**FINAL DRAINAGE REPORT
FOR**

Chick-fil-A Powers & Palmer Park

October, 2025

PCD File No. PPR2521

Engineers Opinion of Probable Construction Costs

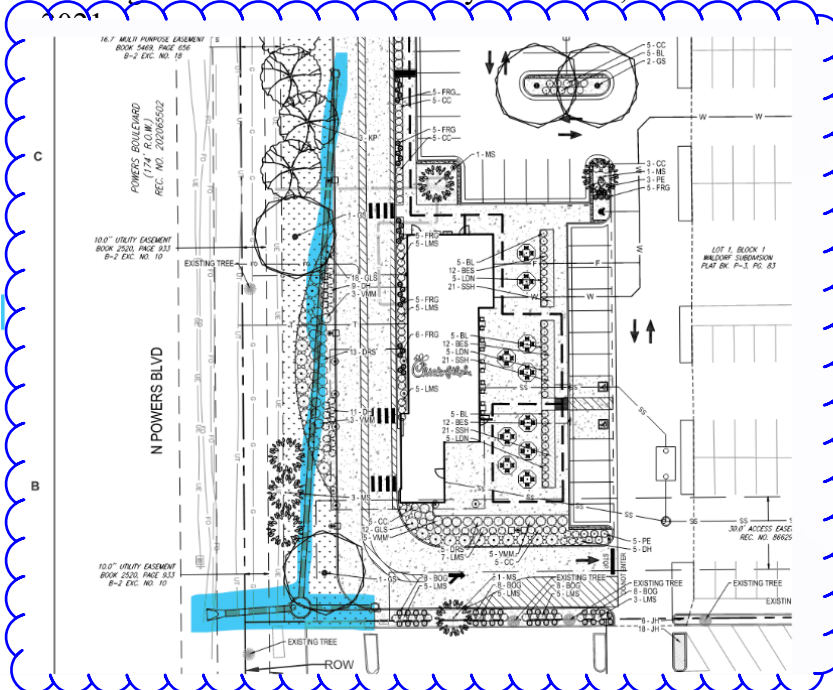
Include a cost estimate for each BR basin with line items for all components (ex: riprap, road base, forebay, trickle channel, outlet structure, outlet pipe, spillway, etc). Input the total value into the FAE form under "Permanent Pond/BMP (provide engineer's estimate)" in Section 1. The total should not include grading, which is a separate line item in Section 1: "Earthwork." The cost estimate should include labor costs (as a separate line item or added into the cost of each component).

SHEET PROPOSED DRAINAGE
BASIN MAP

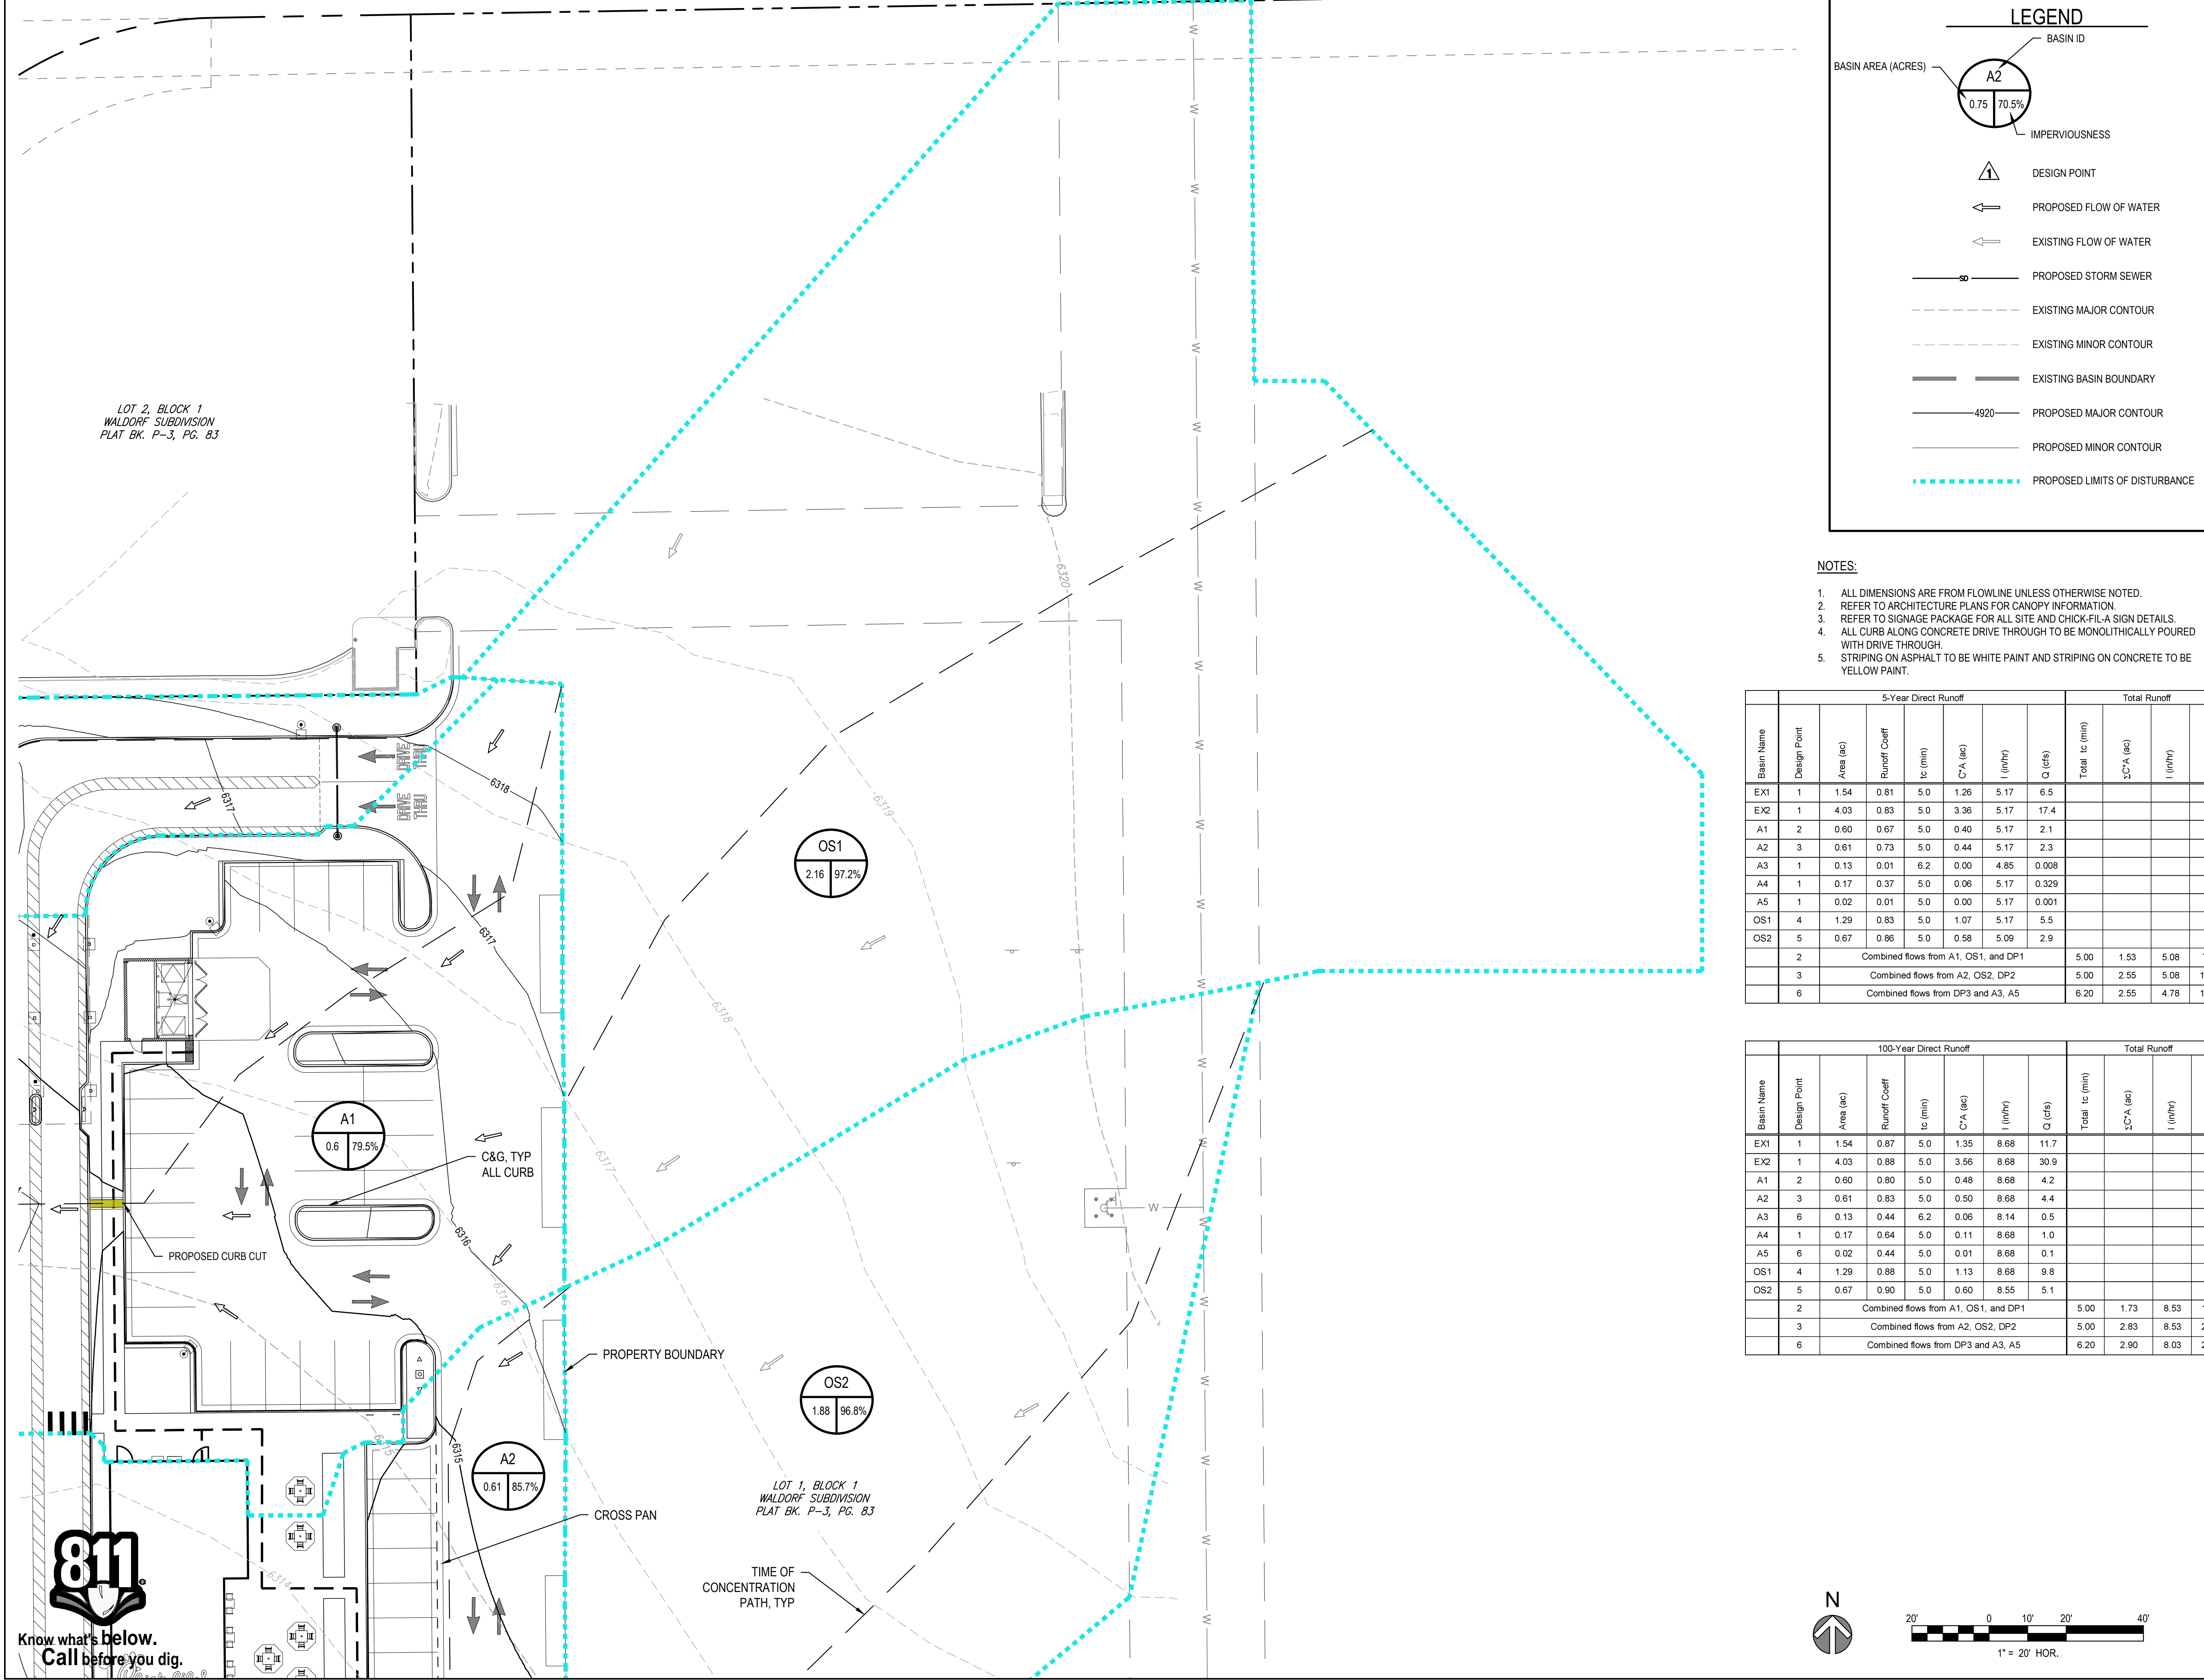
Landscaping design plan shows stormwater pipe. This is not mentioned in the FDR native or shown in the drainage map. Drainage map shows a proposed FES but is missing all pipes.
